**IN THE MATTER OF THE
REQUEST FOR FINAL PLAT
MODIFICATION CONSISTING OF
56 BUILDING LOTS AND 10
COMMON LOTS ON 3.75 ACRES
OF LAND IN THE R-15 ZONING
DISTRICT FOR APEX CADENCE
SUBDIVISION NO. 1**

CASE NO. MFP-2026-0006

STAFF REPORT

SUBJECT: Apex Cadence No. 1 – MFP
MFP-2026-0006

PLAT OF APEX CADENCE SUBDIVISION No. 1

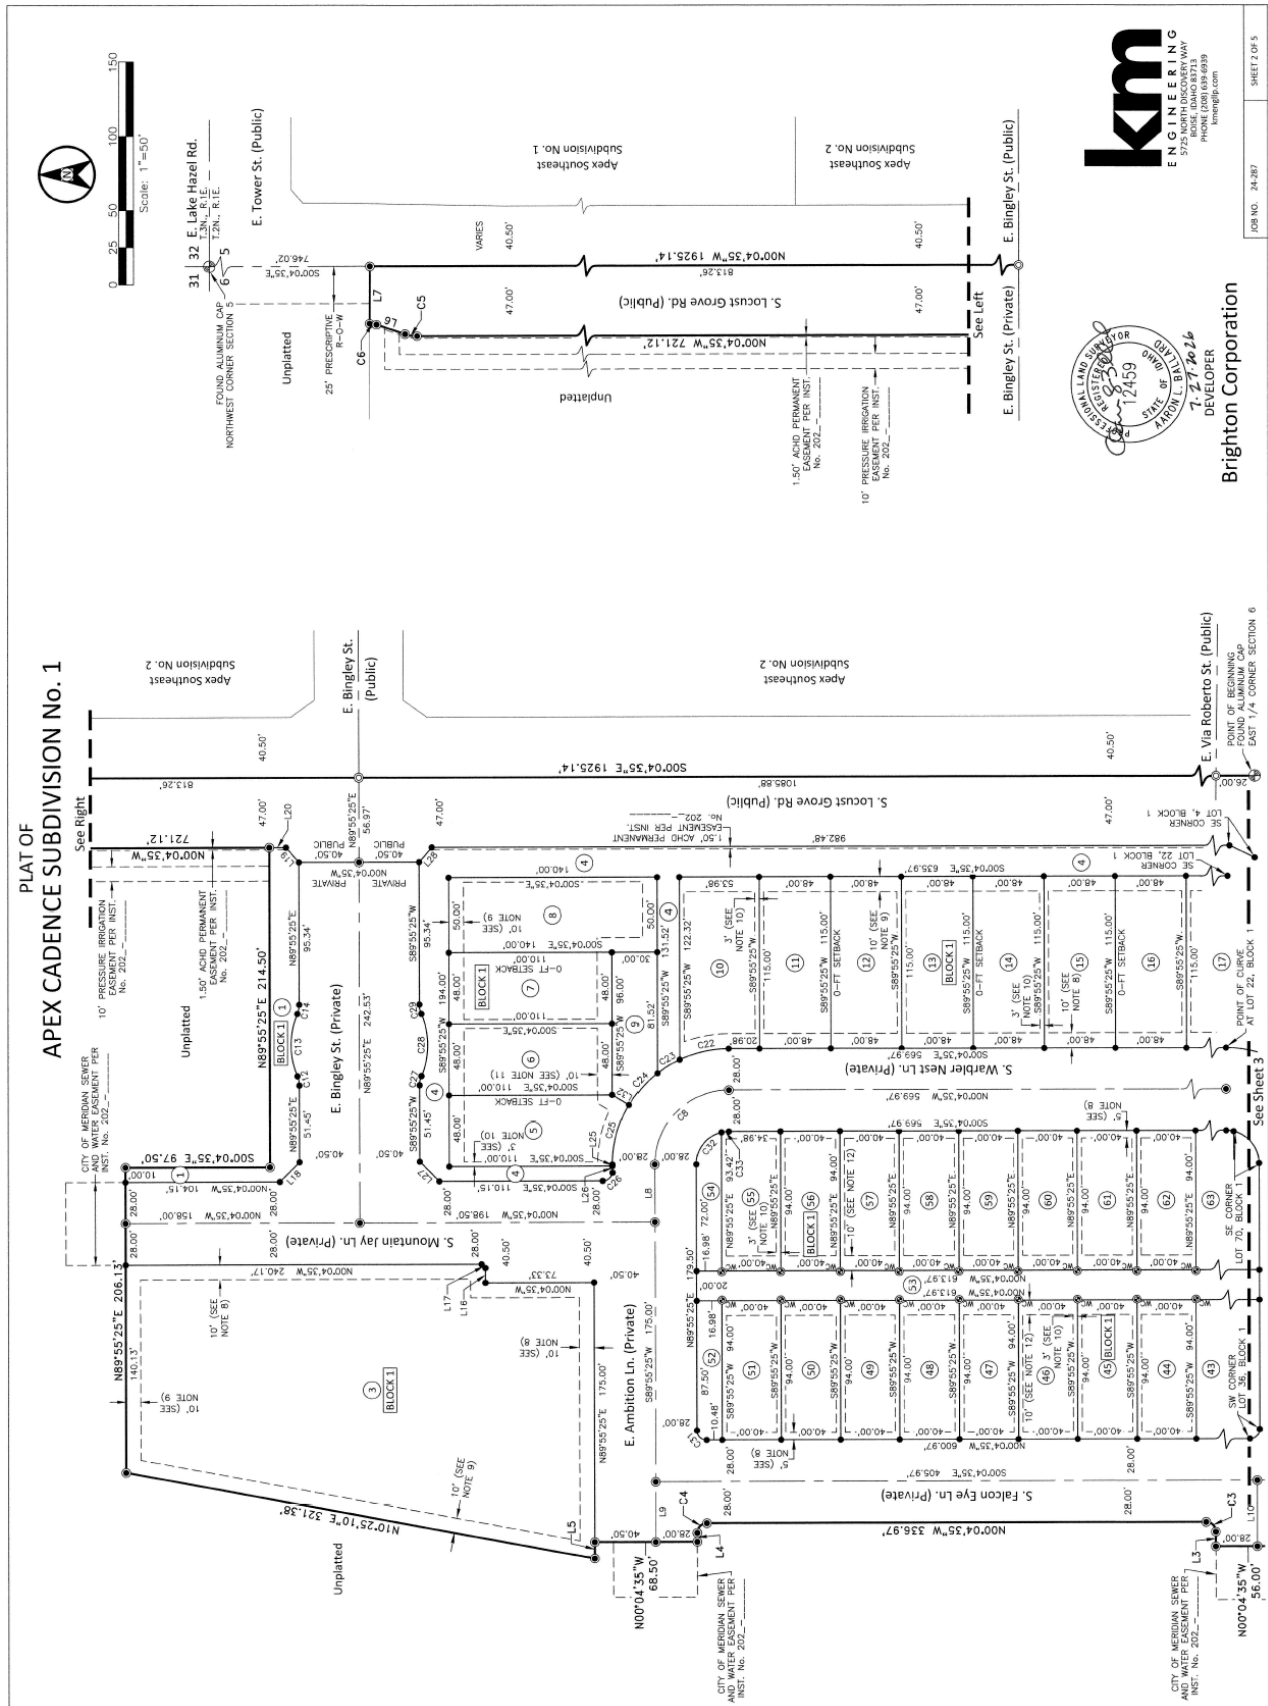
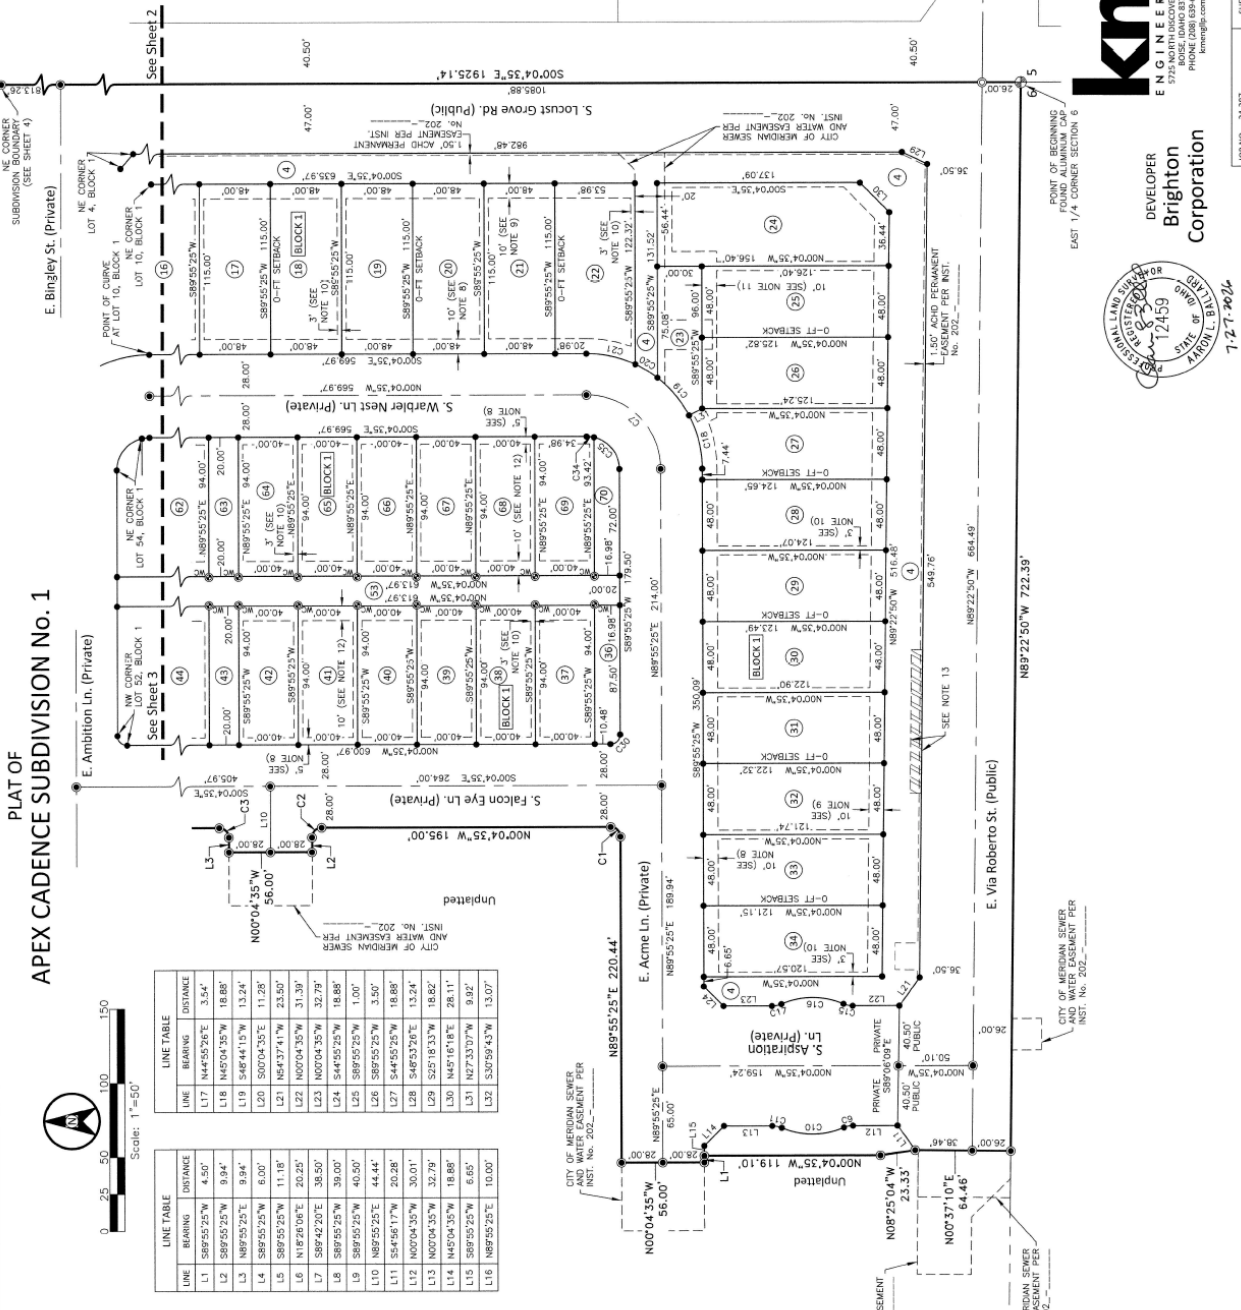
- a. Note #6: Include that the private street shall provide perpetual ingress-egress to all lots in the subdivision; and include the recorded instrument number of the City water and sewer easement.

- b. Note #7: Lots 9 and 23, Block 1 shall be maintained by the homeowner's association, not the adjacent lot owners that take access via the common driveways – revise note accordingly.

- c. Note #11: "As shown hereon, the lots lines common to Lots 9 and 23, Block 1 . . ."
 - d. Note #12: "As shown hereon, the lots lines common to Lot 53, Block 1 . . ."

- e. Note #14: Include the recorded instrument number of the ACHD temporary license agreement.
 - f. Note #15: "Direct lot access to E. Via Roberto St. and S. Locust Grove Rd. is prohibited ~~unless otherwise approved by Ada County Highway District and the City of Meridian.~~"

- g. Note #16: Ensure the recorded instrument number for the CC&R's is correct (the year of the recorded instrument is prior to the approval date of the plat).

- h. Include the recorded instrument number of the City of Meridian sewer and water easement graphically depicted on Sheets 2 and 3.
 - i. Include the recorded instrument number of the ACHD permanent easement graphically depicted on Sheet 2 and 3.

- j. Include the recorded instrument number of the ACHD temporary easement graphically depicted on Sheet 3
 - k. Include the recorded instrument number of the 10' pressure irrigation easement on Sheet 2.

- l. If the multi-use pathways/sidewalks along E. Via Roberto St. and S. Locust Grove Rd. aren't located entirely within the right-of-way, public use easement(s) shall be depicted on the plat.

- m. Depict the easement for the Watkins Drain, if applicable.
 - n. Extend Lots 9 and 23, Block 1 along the frontage of Lots 8 and 24, Block 1.

APEX CADENCE SUBDIVISION NO. 1
MERIDIAN, IDAHO
LANDSCAPE CONSTRUCTION SET

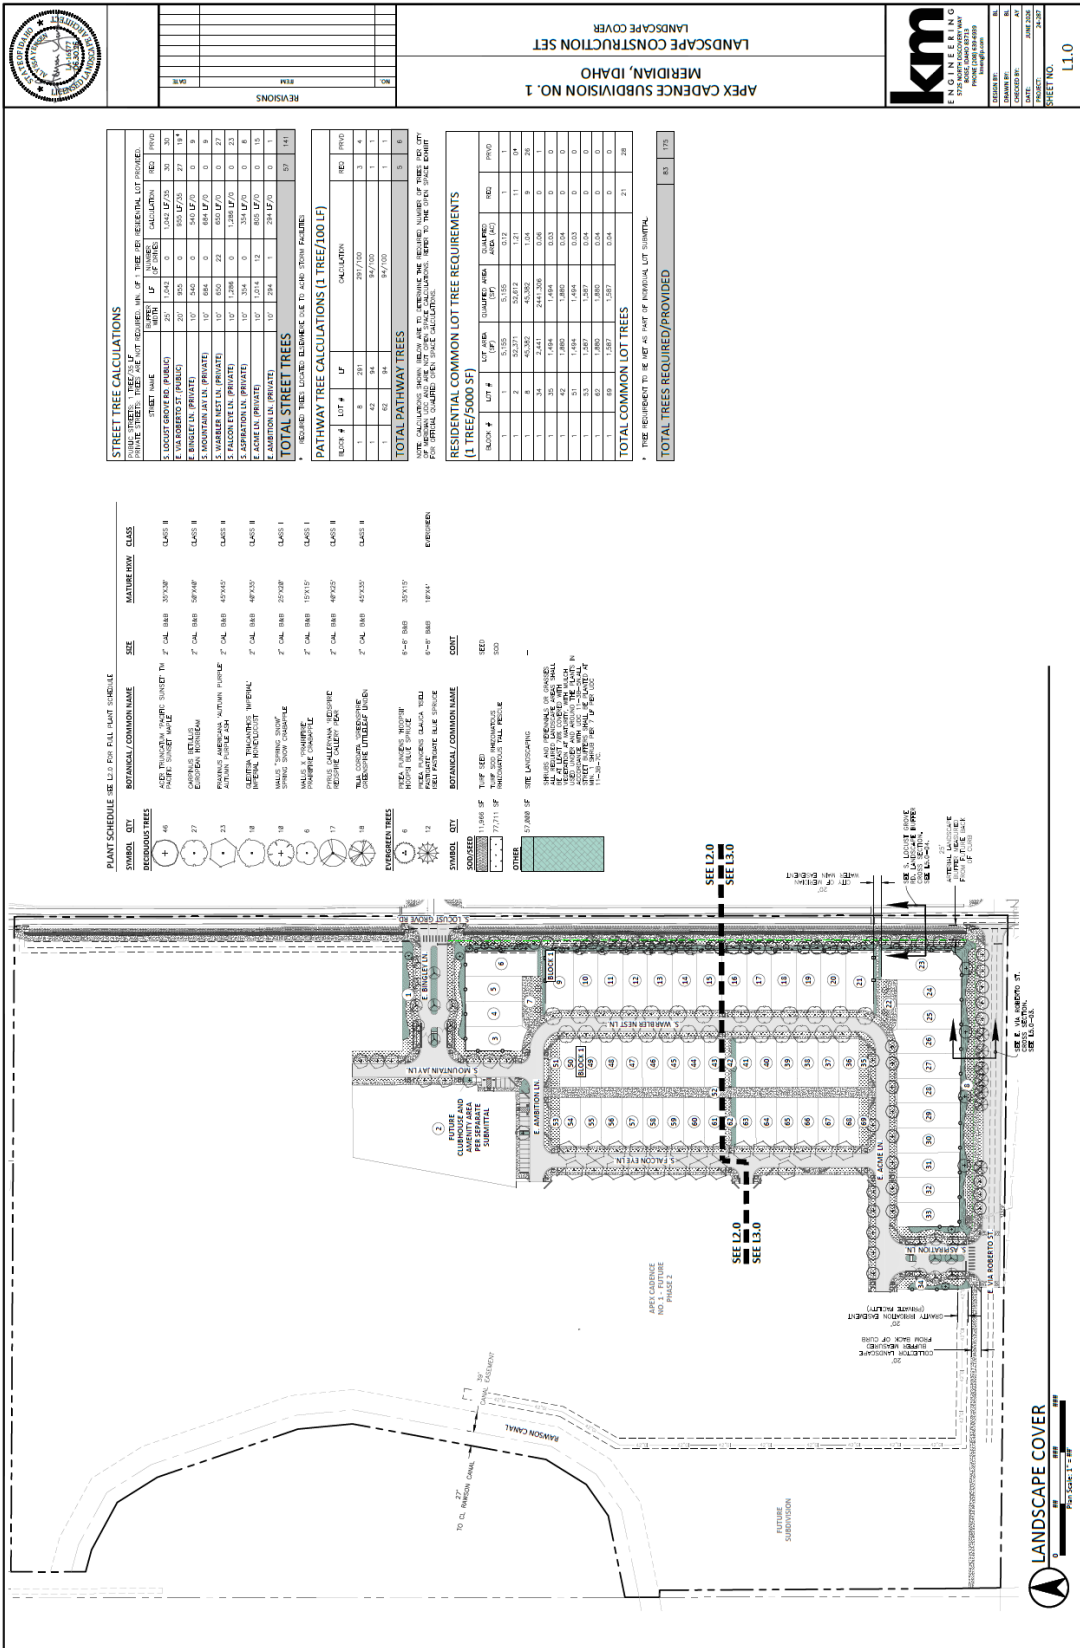
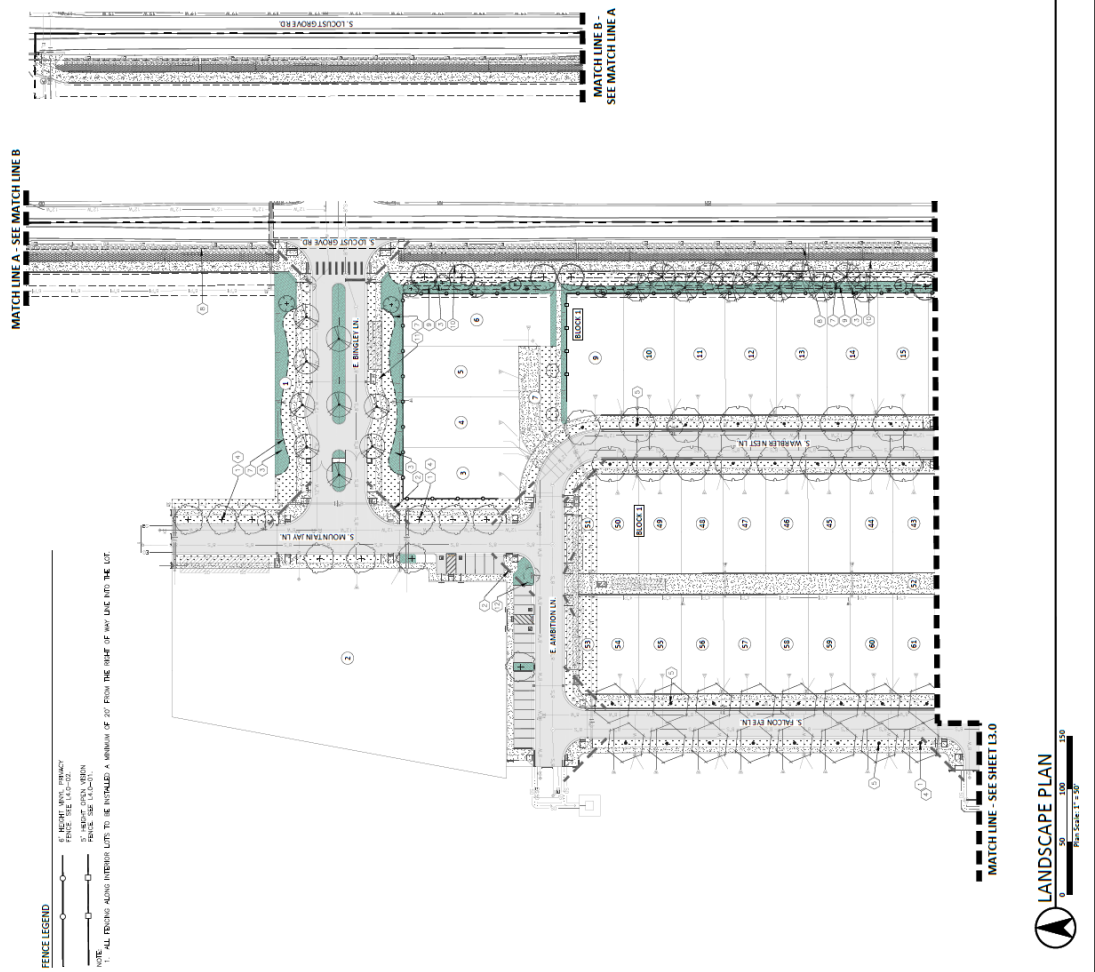
5. The landscape plan prepared by KM Engineering, dated 06/30/2026, included in Section V.D, shall be revised as follows:
 - a. Depict enhanced landscaping within the street buffers along S. Locust Grove Rd., an arterial street, and E. Via Roberto St., a collector street, in accord with the standards listed in UDC 11-3B-7C. and 11-3G-3B.3. Include a note stating what the enhanced landscaping consists of.

- b. Include tree mitigation calculations on the landscape plan in accord with the standards in UDC 11-3B-10C.5, as applicable.
 - c. Correct Detail #4 on Sheet L5.0 to reflect a 10' wide detached sidewalk/pathway rather than a 5' wide detached sidewalk/pathway along Locust Grove Rd.

- e. Depict fencing abutting pathways and common open space lots to distinguish common from private areas as set forth in UDC 11-3A-7A.7.
 - f. Extend Lots 9 and 23, Block 1 along the frontage of Lots 8 and 24, Block 1 and extend landscape strips along common driveways.

LANDSCAPE CONSTRUCTION SET
MERIDIAN, IDAHO
APEX CADENCE SUBDIVISION NO. 1
FENCE PLAN

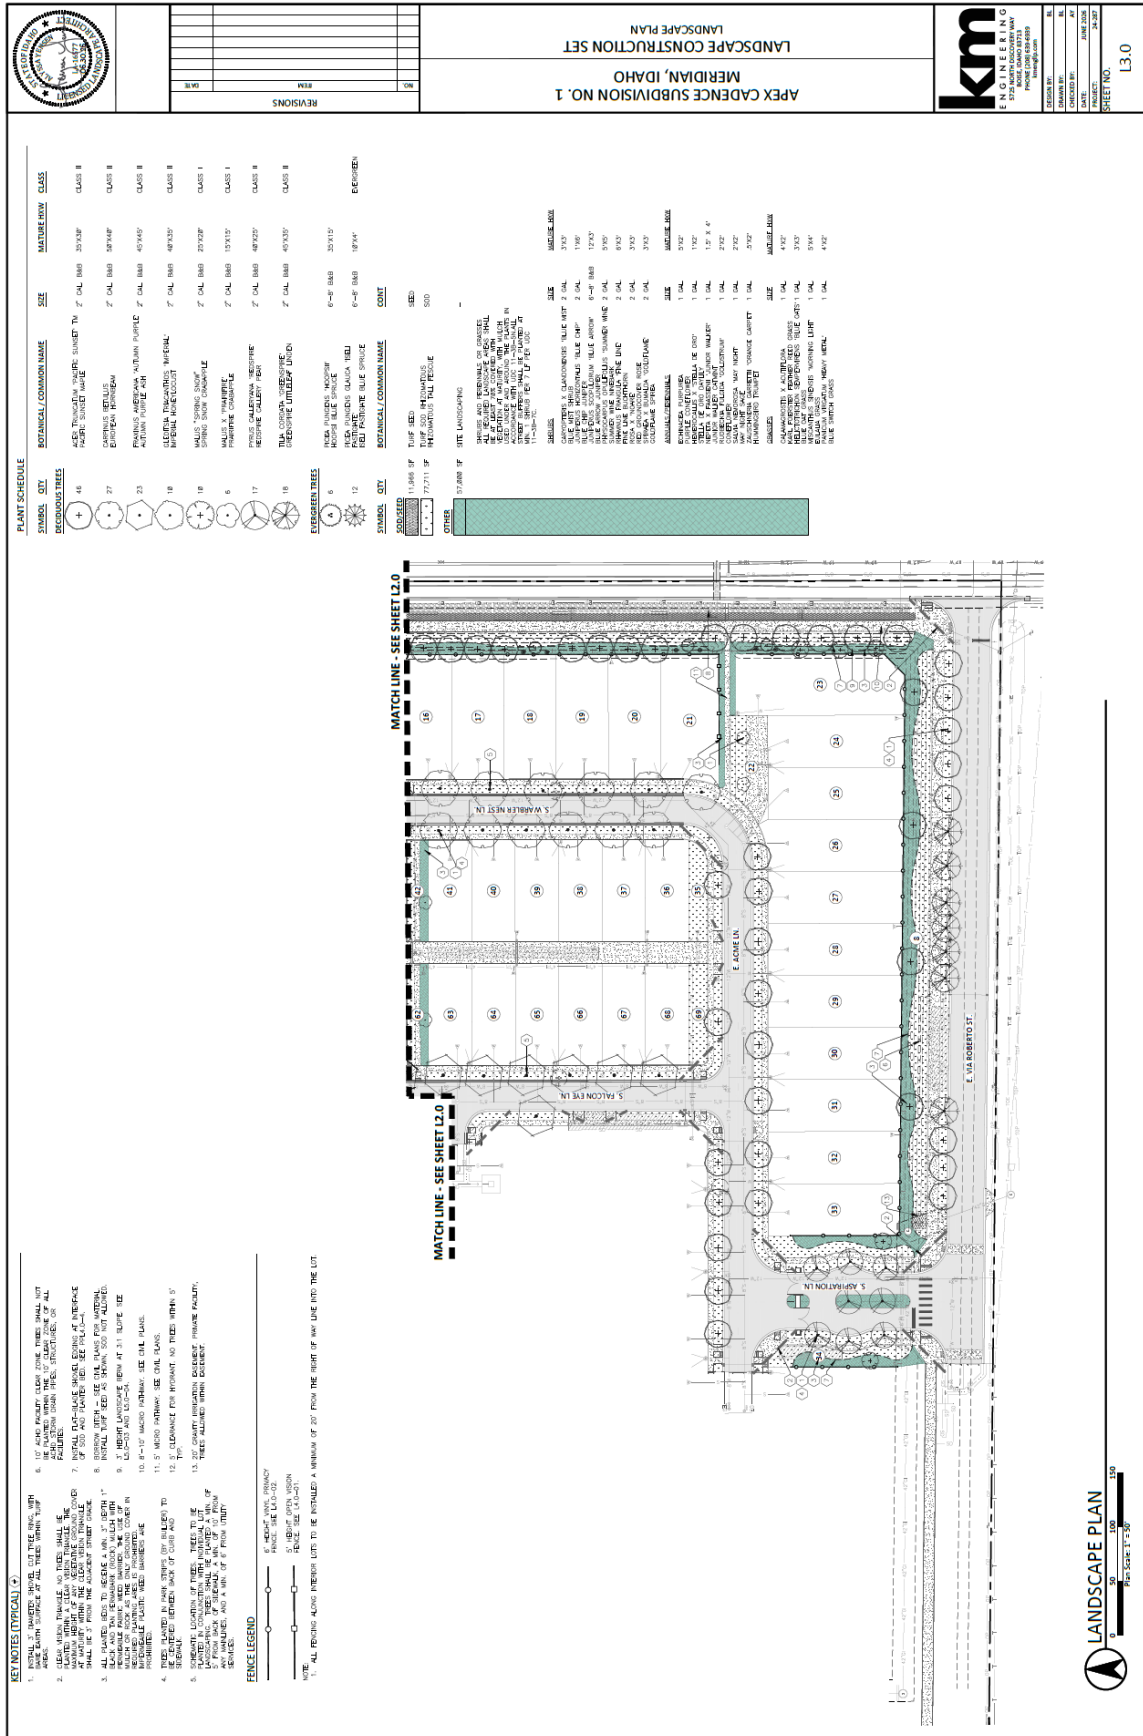
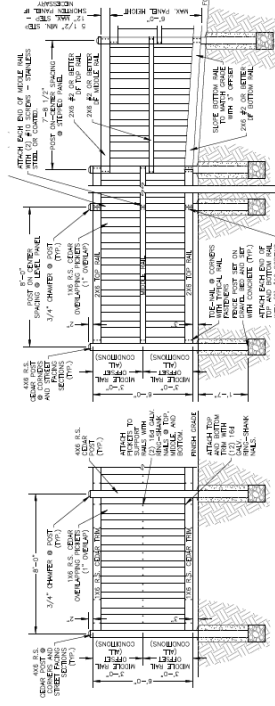
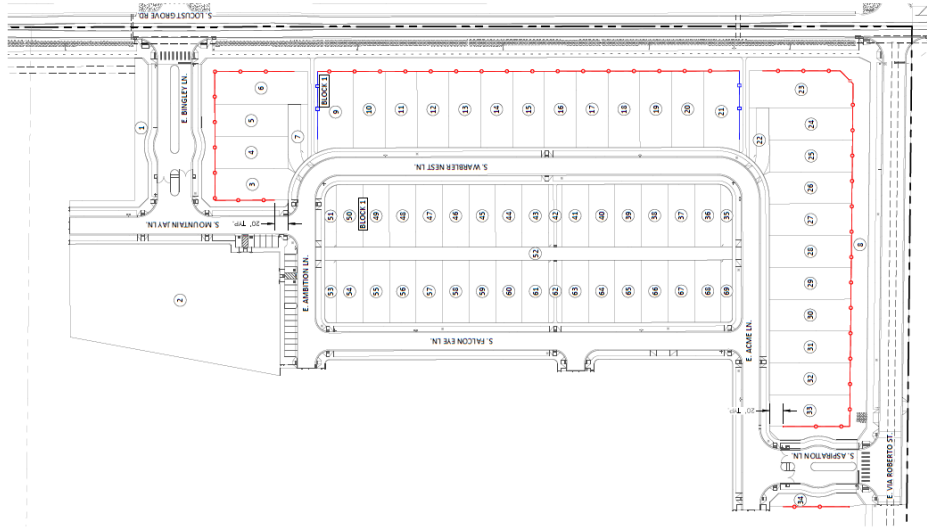
- d. The 6' height vinyl privacy fence depicted in the Fence Legend doesn't match Detail 2 on Sheet L4.0, which is a 6' height stained cedar fence – revise accordingly.
